Subject: Duke Energy Corporation
Oconee Nuclear Station - Units 1, 2, and 3
Docket Nos. 50-269, 50-270, and 50-287

Revisions to Topical Report DPC-NE-3003 In Support of
Steam Generator Replacement
Response to NRC Staff Request for Additional
Information

Duke Power Response To Request For Additional Information

DPC-NE-3003 Revision 1 “Mass and Energy Release and Containment Response Methodology”

(14.1 ft² Break - RV Outlet - High Initial RCS Flow w/ M3 Pump Degradation Model)

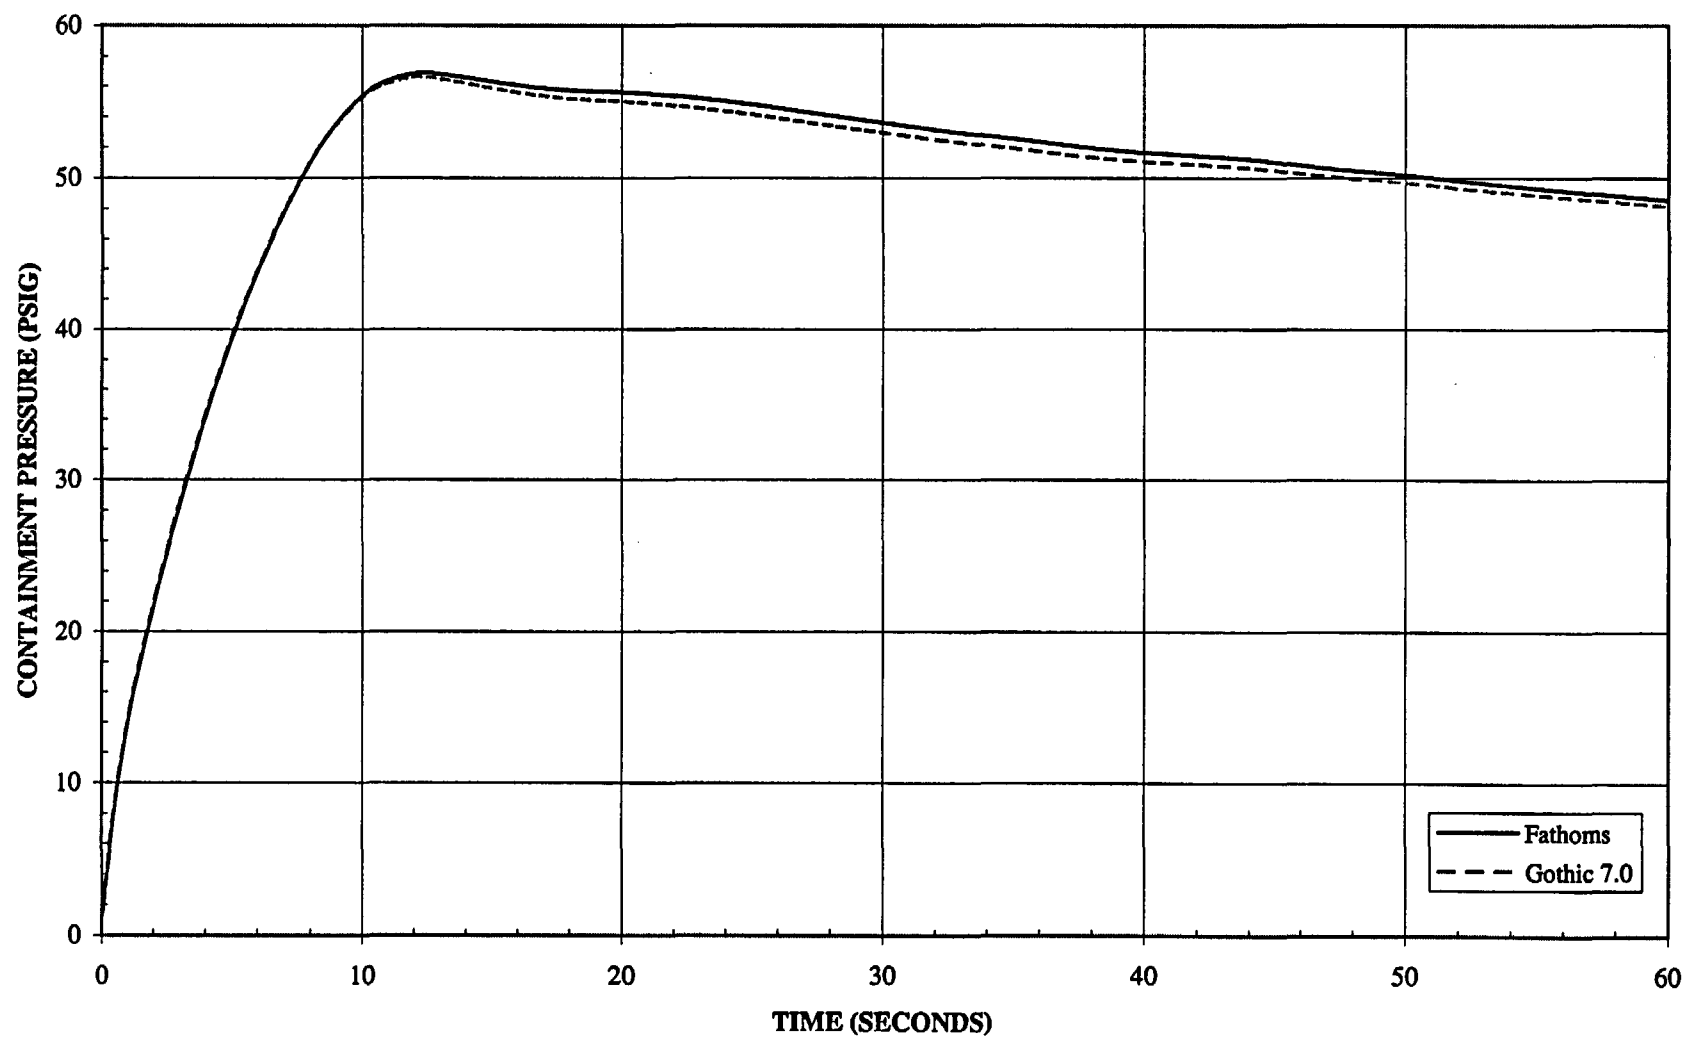
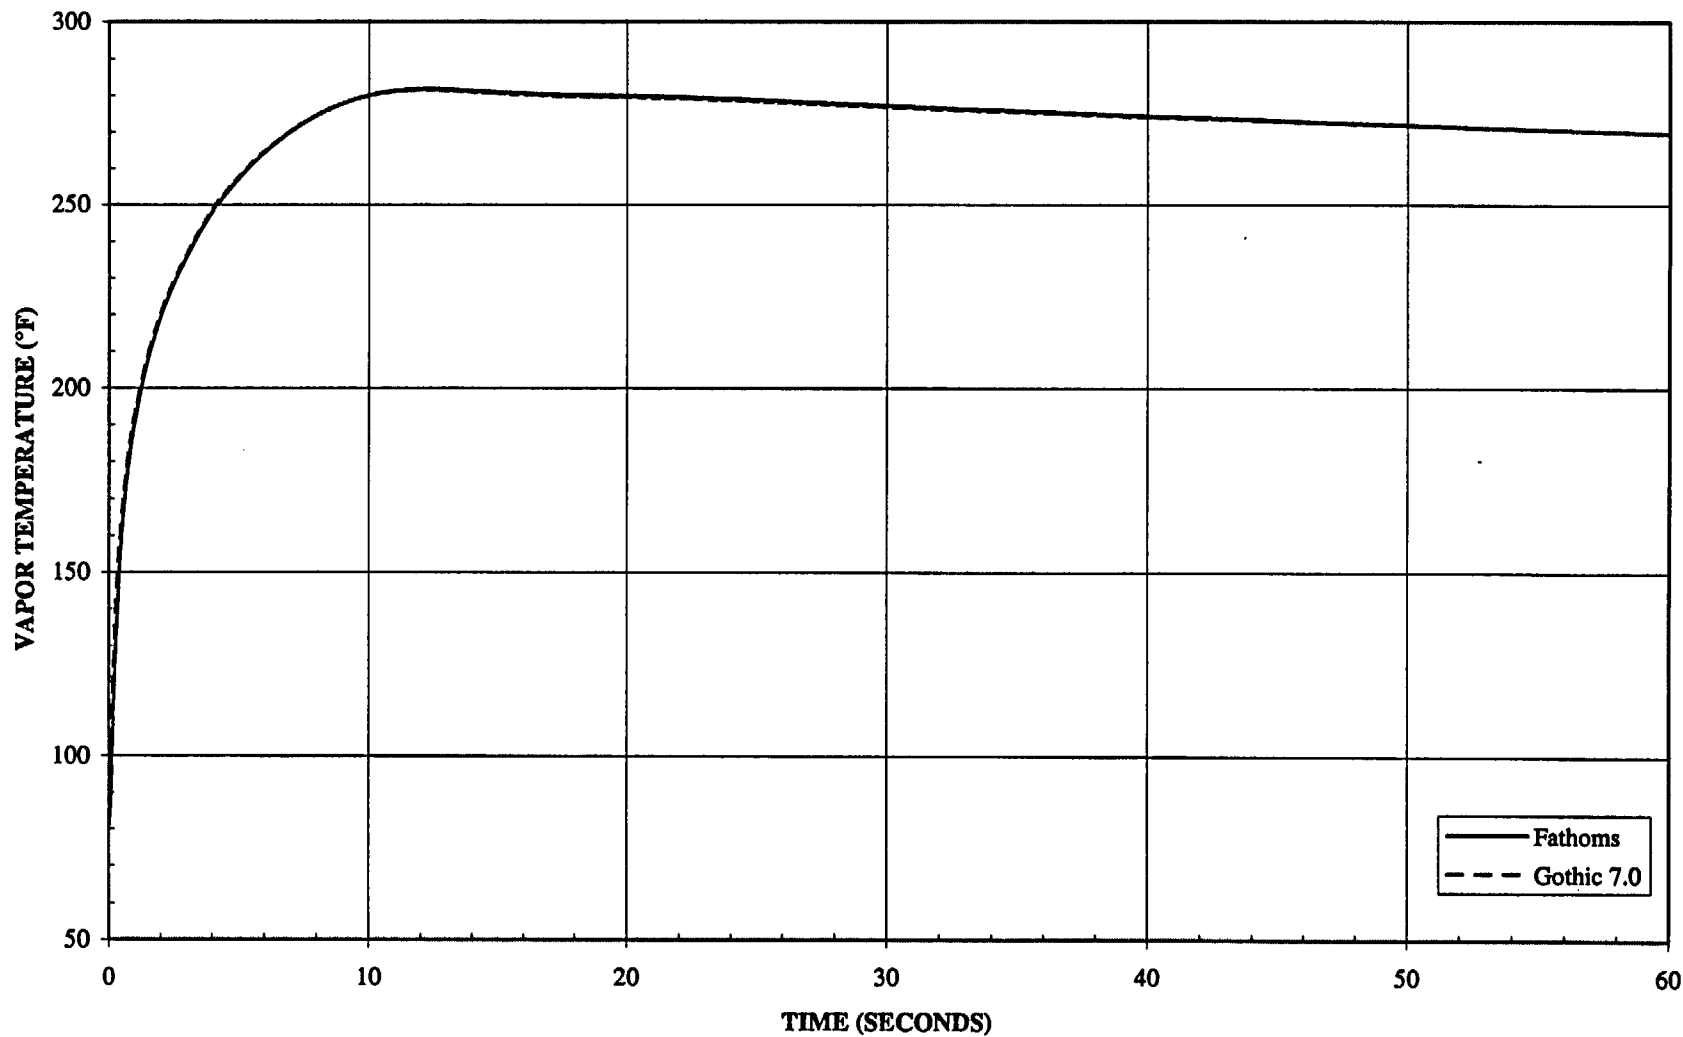
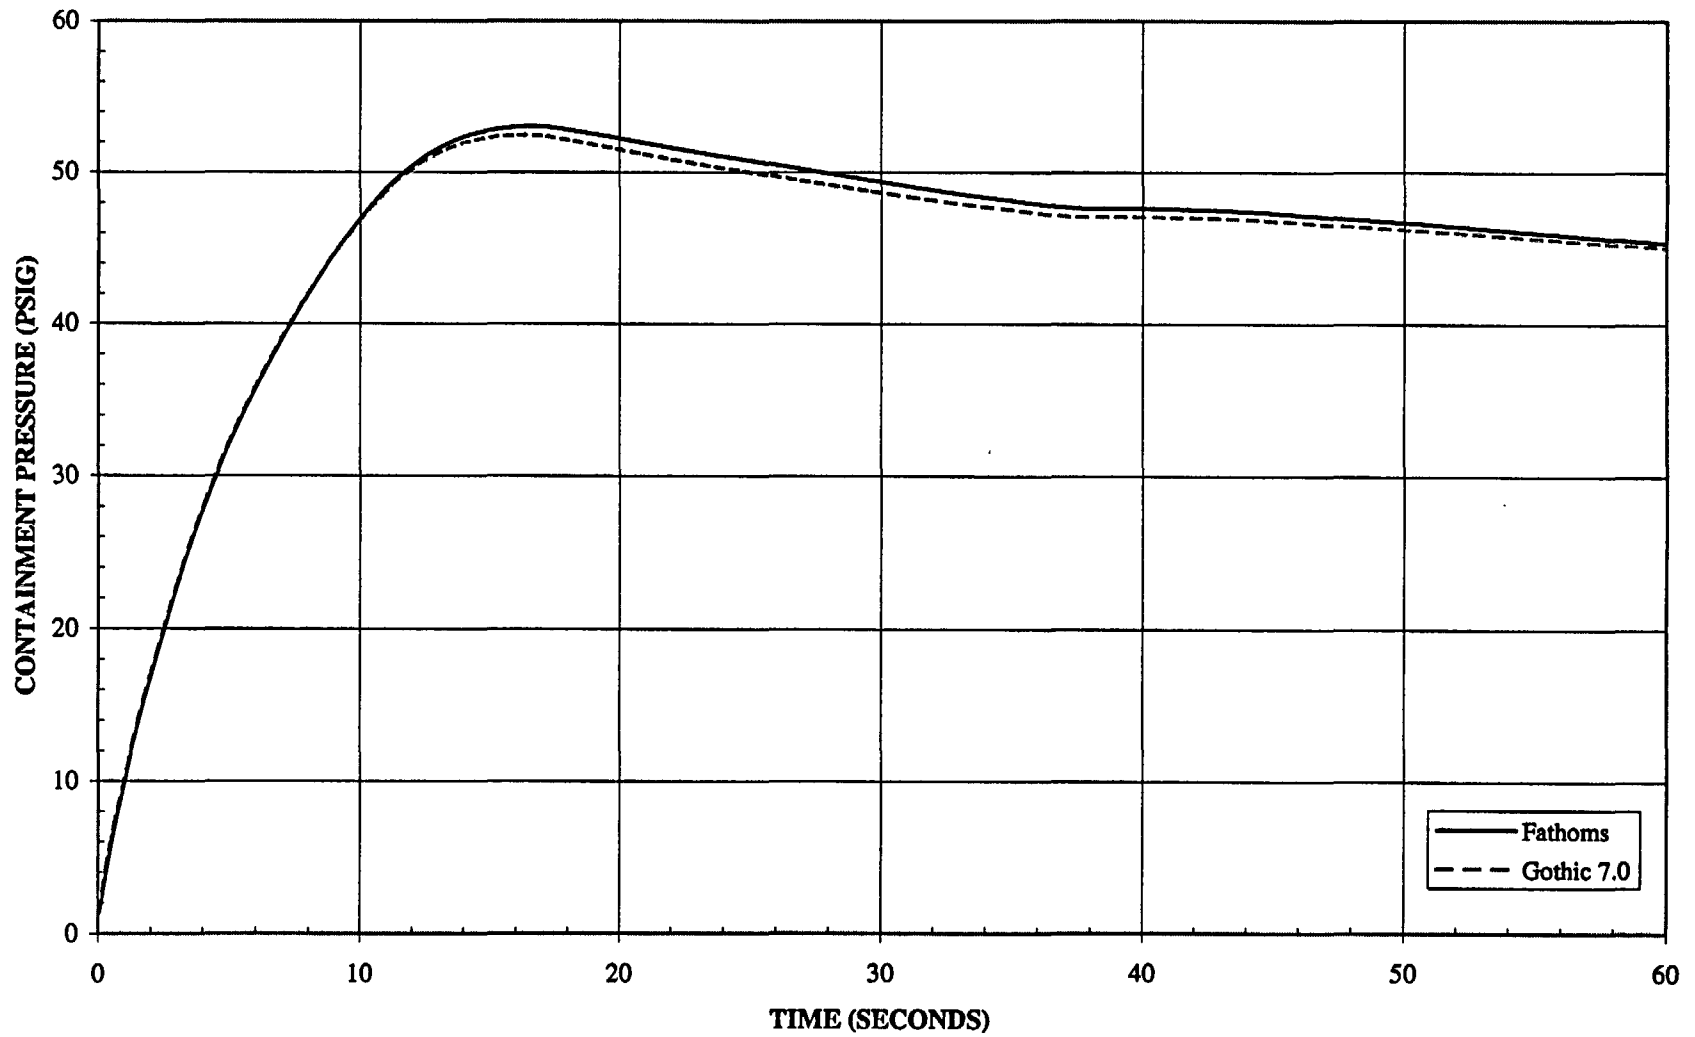
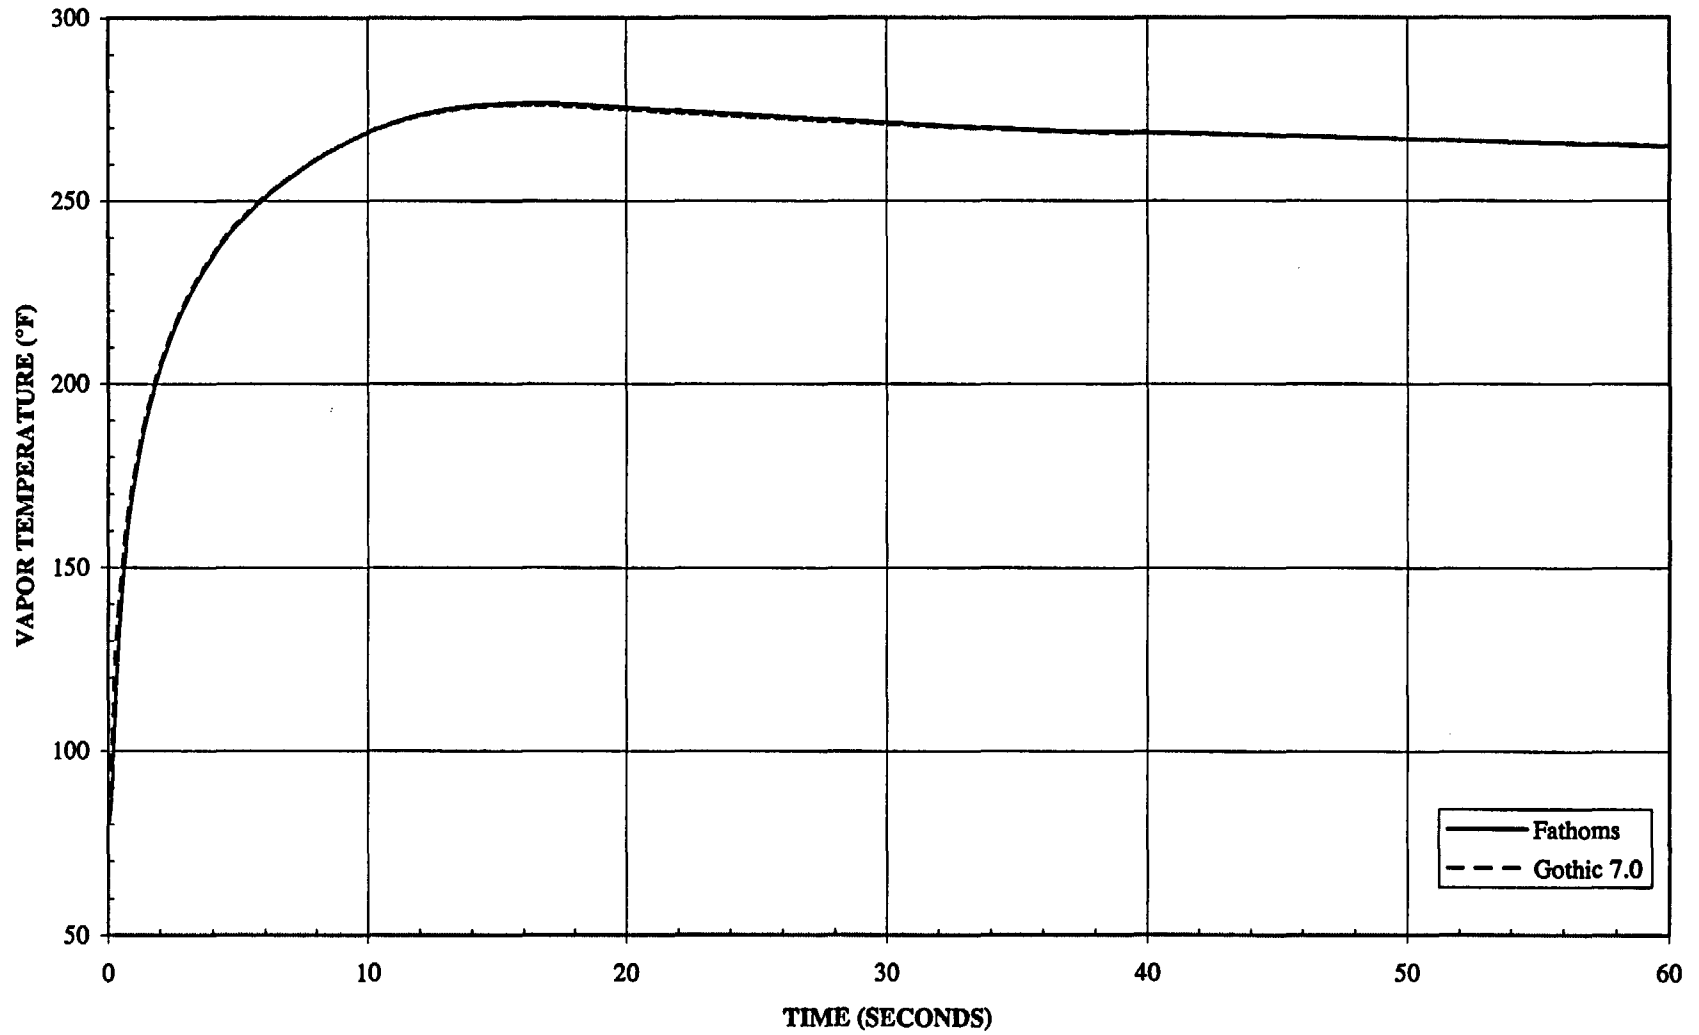
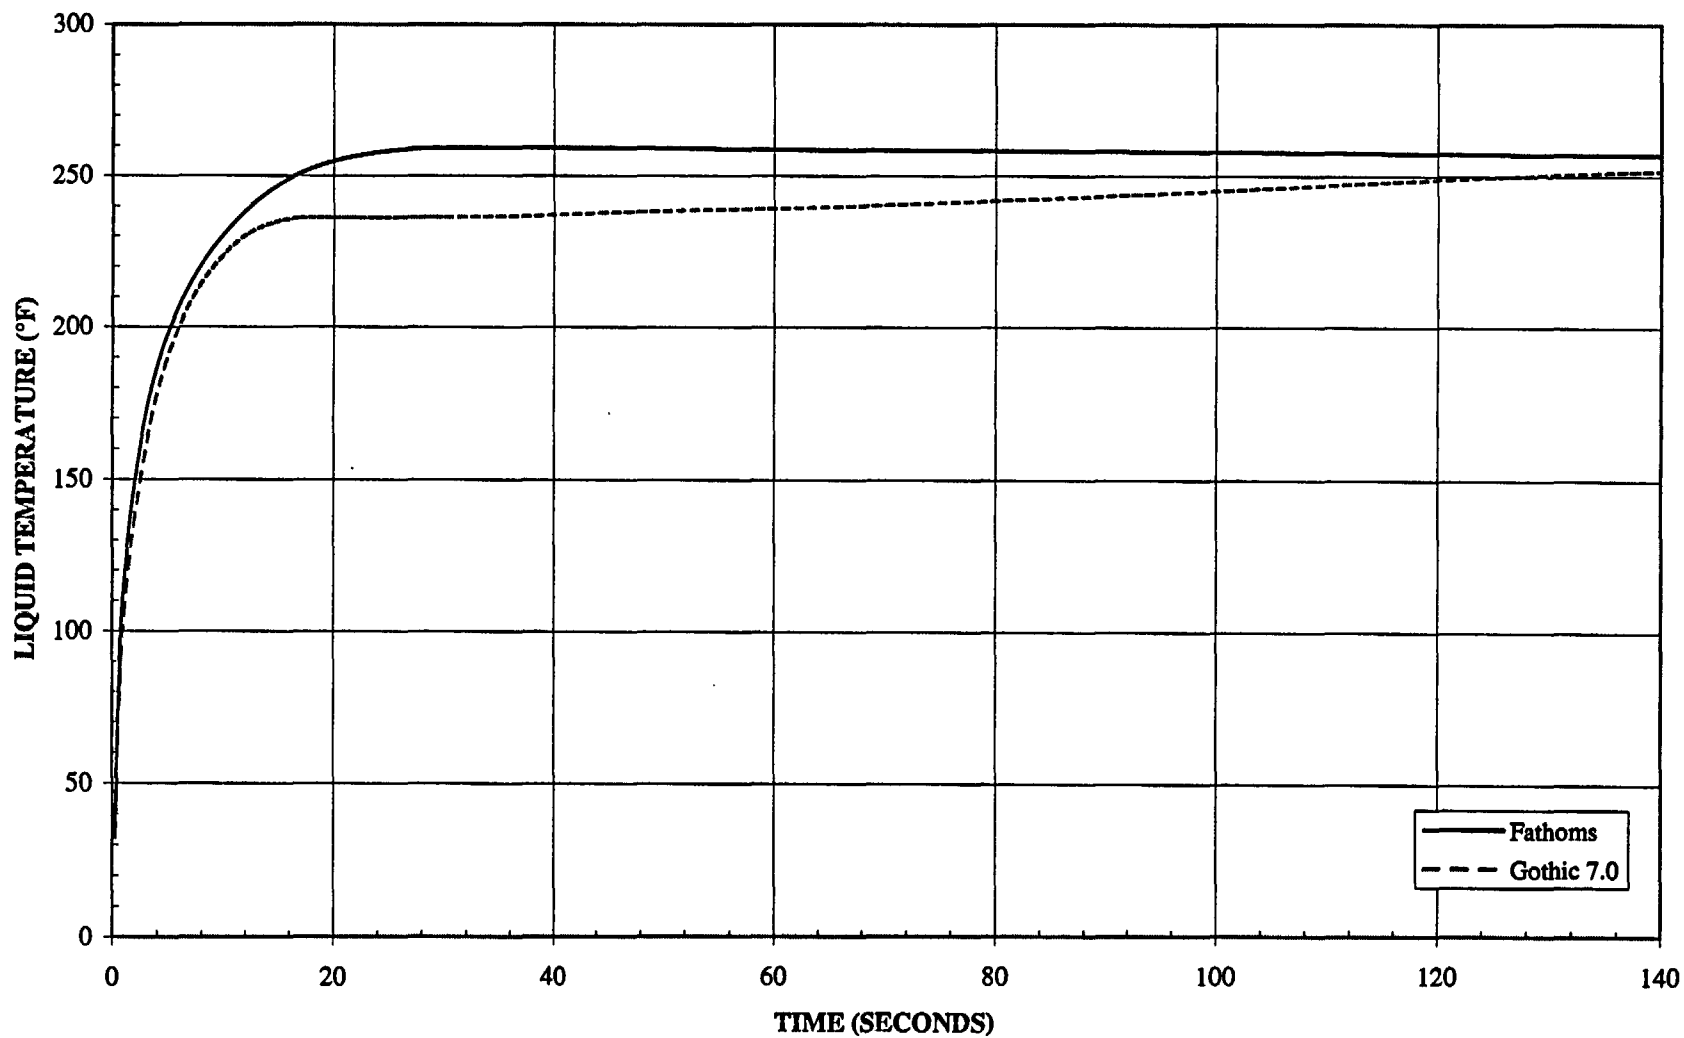
3. Please provide the results using the GOTHIC 7.0 code of peak pressure and temperature calculations for the sensitivity cases listed in Table 3.1-1 of DPC-NE-3003 in tabular and graphical form. If the results or conclusions are significantly different from those presented in DPC-NE-3003P, explain the difference.

Response: Table 3.1-1 of DPC-NE-3003 describes a spectrum of LOCA peak pressure cases including a range of break locations and sensitivity analyses for several important modeling assumptions. The staff's request is understood to focus on the difference in the predicted results from the FATHOMS and GOTHIC 7.0 code versions. Rather than show the comparison for the cases in Table 3.1-1, a different set of cases has been selected which is more focused on the current knowledge of the key sensitivity parameters. Also, the results presented are for the ROTSGs, which is the subject of Revision 1 to the topical report.

The results of the 14 code comparison analyses are shown in Table 3-1 below and in the figures that follow. In general, the pressure and vapor temperature response predictions were very similar in both magnitude and trend. GOTHIC 7.0 predictions for peak pressures and vapor temperature were slightly lower (~0.5 psig and 0.5°F). These differences are consistent with the code model differences described in the response to Question #1. Both codes predict a saturated containment atmosphere due to the large amount of drops injected. The slightly lower pressure, vapor temperature, and liquid temperature from GOTHIC 7.0 may be attributed to additional drop hold up in the atmosphere. This effectively increases the heat capacity of the atmosphere and reduces the temperature rise for a given energy addition. A comparison of the total liquid and drop masses, and liquid temperatures, show the predictions of the two codes to be essentially the same. This is consistent with the changes in the drop deposition and entrainment models discussed in Question #1. These results show that the two code versions give essentially similar results for the same break location and initial and boundary conditions.
